HUNTS POINT INTERSTATE ACCESS IMPROVEMENT PROJECT – CONTRACT 3

PIN X731.65, Contract D900055

Addendum #10

August 5, 2022

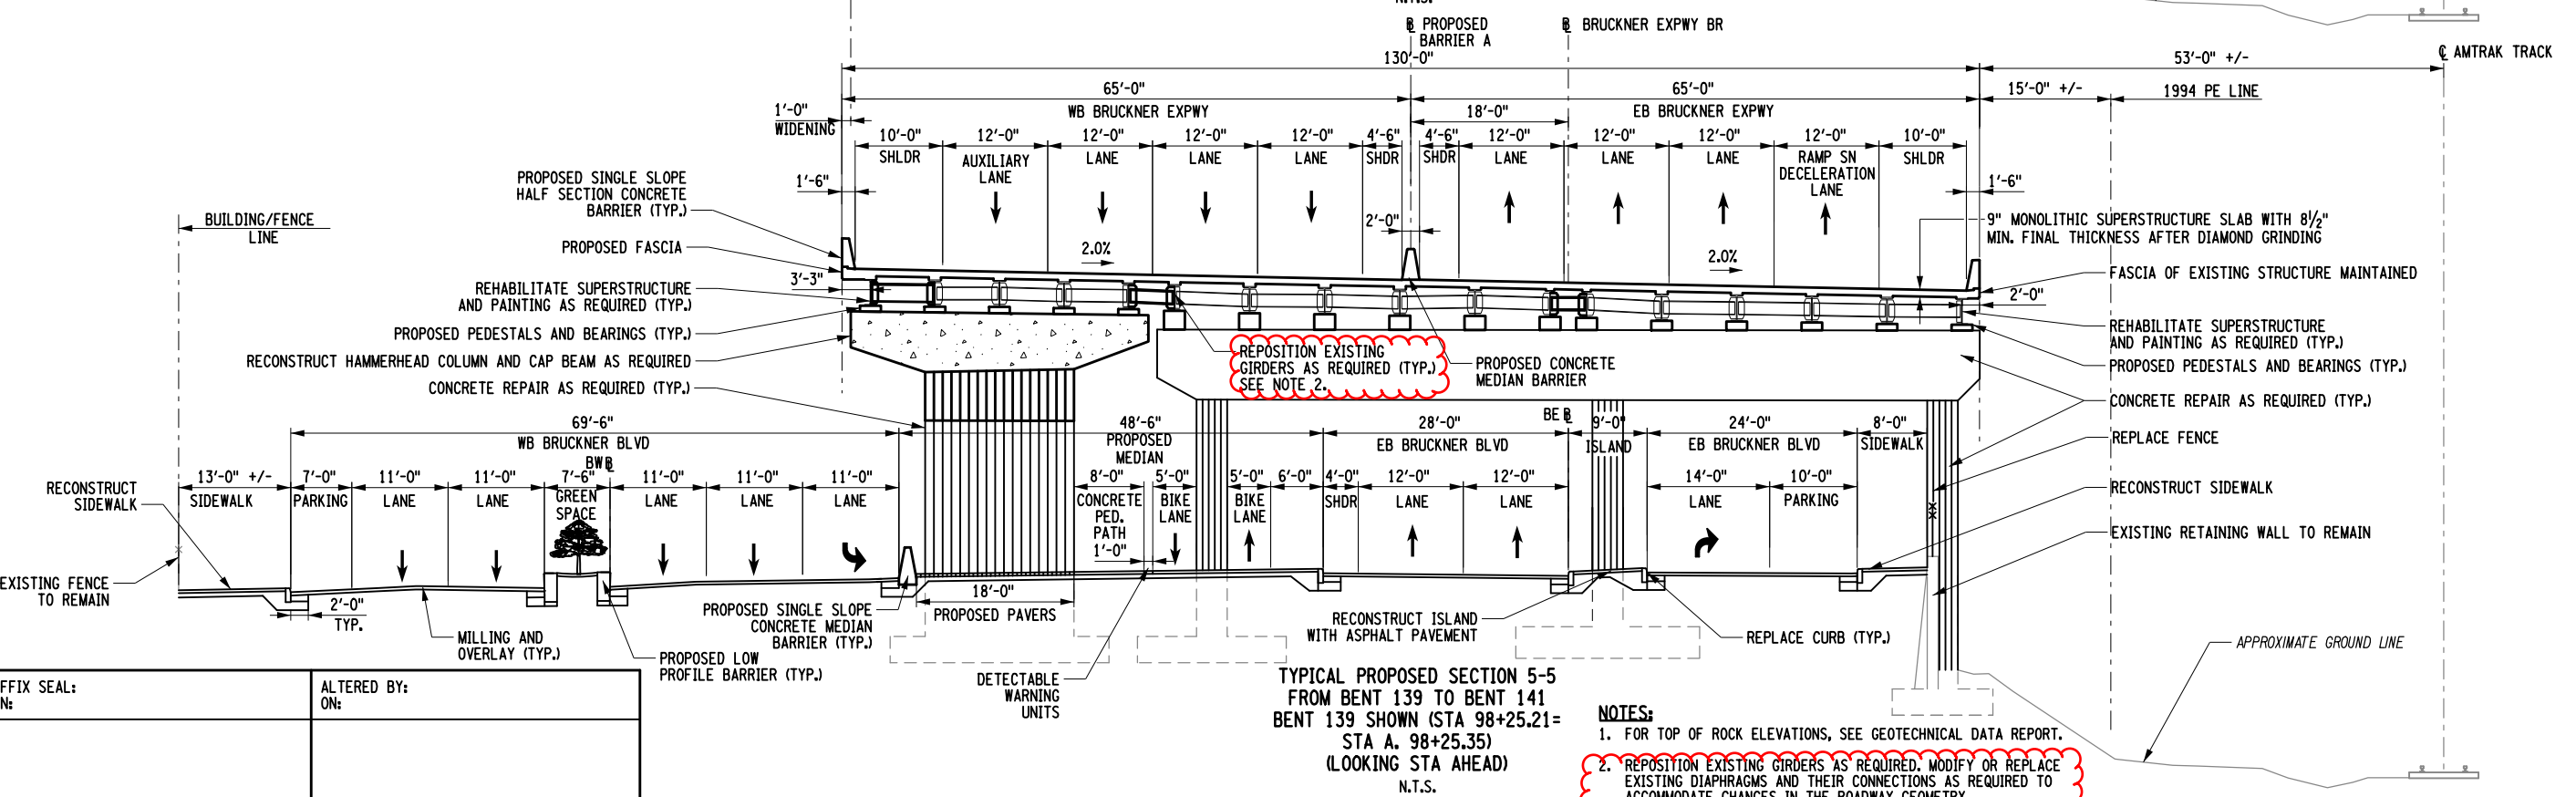
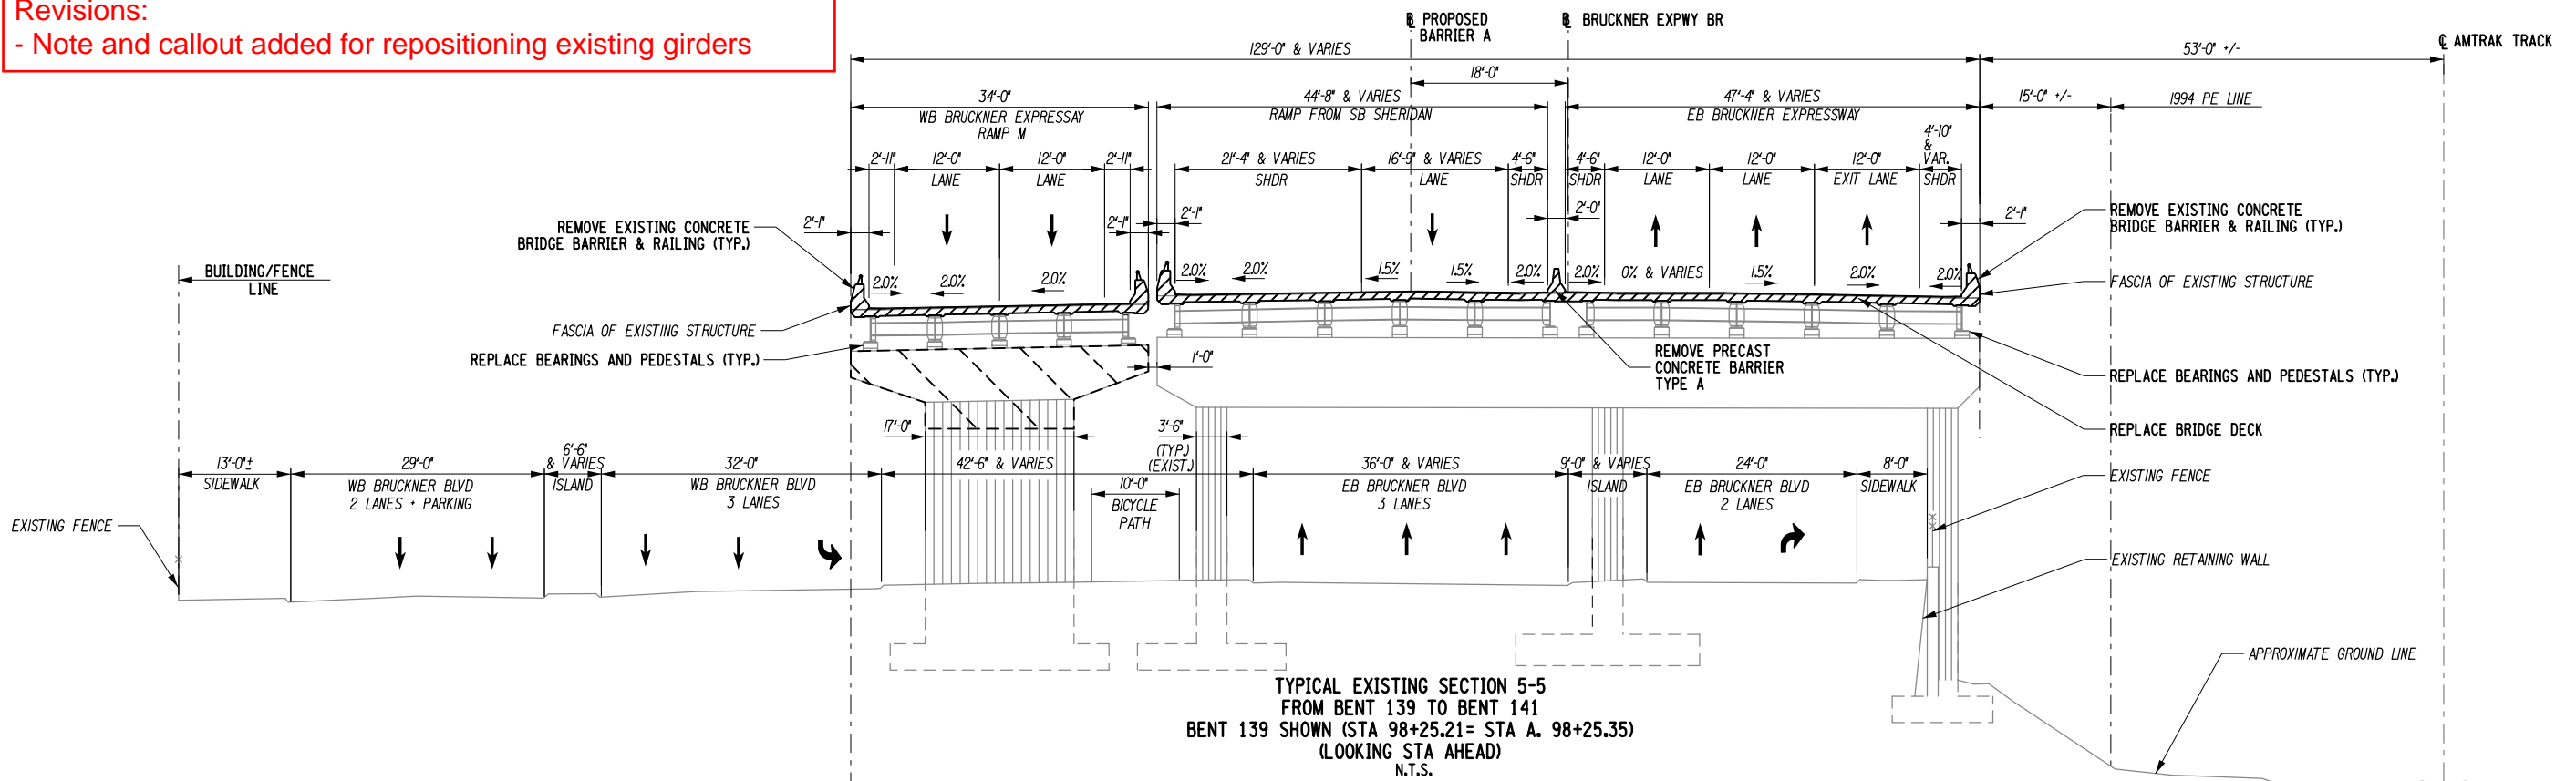
Revisions:
- Note and callout added for repositioning existing girders
